EASA	AIRWORTHINESS DIRECTIVE
	<p>AD No.: 2013-0062</p> <p>Date: 11 March 2013</p> <p>Note: This Airworthiness Directive (AD) is issued by EASA, acting in accordance with Regulation (EC) No 216/2008 on behalf of the European Community, its Member States and of the European third countries that participate in the activities of EASA under Article 66 of that Regulation.</p>
<p>This AD is issued in accordance with EC 1702/2003, Part 21A.3B. In accordance with EC 2042/2003 Annex I, Part M.A.301, the continuing airworthiness of an aircraft shall be ensured by accomplishing any applicable ADs. Consequently, no person may operate an aircraft to which an Airworthiness Directive applies, except in accordance with the requirements of that Airworthiness Directive unless otherwise specified by the Agency [EC 2042/2003 Annex I, Part M.A.303] or agreed with the Authority of the State of Registry [EC 216/2008, Article 14(4) exemption].</p>

<p>Design Approval Holder's Name :</p> <p>Mecaer Aviation Group S.p.A.</p>	<p>Type/Model designation(s) :</p> <p>NH-300C helicopters</p>
<p>TCDS Number(s) : EASA.R.143</p>	
<p>Foreign AD : Not applicable</p>	
<p>Supersedure: This AD supersedes EASA AD No. 2011-0

Figure 1. – Tailboom Support Strut Adjustable Diameter Bolt Inspection - Replacement

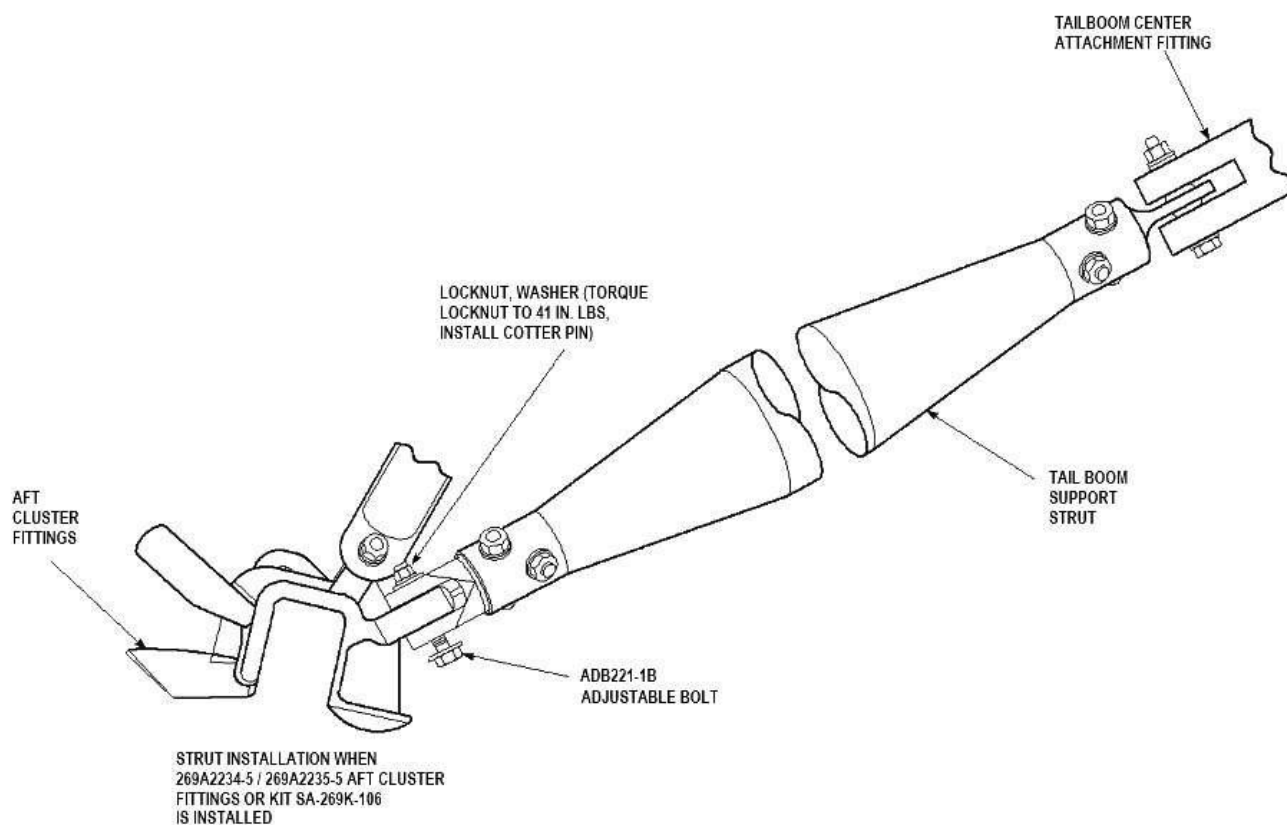
<p>modification kit P/N SA-269K-106 to verify that there is sufficient drag torque, that both locknuts are properly torqued and, if necessary, their replacement.</p> <p>This AD, which supersedes AD 2011-0027 partially retaining its requirements, additionally requires to modify each adjustable diameter bolt included in the aft cluster fitting modification kit P/N SA-269K-106 or to install a different adjustable diameter bolt, allowing the installation of a secondary safety mechanism: a cotter pin which prevents separation of strut and driveshaft from the helicopter and subsequent loss of control of the helicopter.</p>
Effective Date:	25 March 2013
Required Action(s) and Compliance Time(s):	<p>Required as indicated, unless already accomplished:</p> <ol style="list-style-type: none"> (1) Within 25 FH or 30 days after 15 March 2011 [effective date of AD 2011-0027], whichever occurs first, inspect the tailboom aft cluster fitting strut to determine whether the aft cluster fitting modification kit P/N SA-269K-106 is installed. (2) If modification kit P/N SA-269K-106 is installed, before next flight after 11 March 2011 [effective date of AD 2011-0027], remove the two locknuts, P/N MS21043-3, installed on the adjustable diameter bolts attaching the tailboom struts to the aft cluster fittings. Reinstall the locknuts while determining the locknut drag torque. If the drag torque is 2 in-lbs or more, retorque the locknut to 23 inch-pounds (in-lbs) plus maximum drag torque of 18 in-lbs for a final torque of 41 in-lbs. If the drag torque is less than 2 in-lbs, replace the locknuts with serviceable locknuts and torque to 23 in-lbs plus a maximum drag torque of 18 in-lbs for a final torque of 41 in-lbs. (3) Within 10 FH after the effective date of this AD, replace each adjustable diameter bolt P/N ADB221-1A with an adjustable diameter bolt P/N ADB221-1B, install washer and locknuts P/N MS21043-3 using torque values specified in paragraph (2) of this AD, and install cotter pins on the adjustable diameter bolts, P/N MS24665-132 or MS24665-151 as shown in Appendix 1, Figure 1. of this AD. (4) From the effective date of this AD, do not install aft cluster fitting modification kit P/N SA-269K-106 on any helicopter, unless in accordance with the requirements of this AD.
